SP-25-002 River Hill Estates

Planning Board Meeting September 18, 2025

Planning Board Evaluation and Approval

Scenic Road Plan and Profile

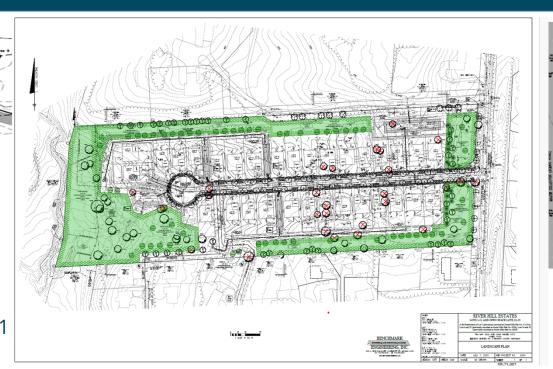
Access:

Whenever practical, access shall be located along a non-scenic road.

Access is only from Trotter Road. No other potential access points.

Only to the extent vehicular access cannot be practicably located along a non-scenic road, access along a scenic road shall be permitted at an existing driveway location.

Applicant proposes a public road in the location of 1 of the 4 existing driveways. The public road will provide a single point of access to the subdivision.
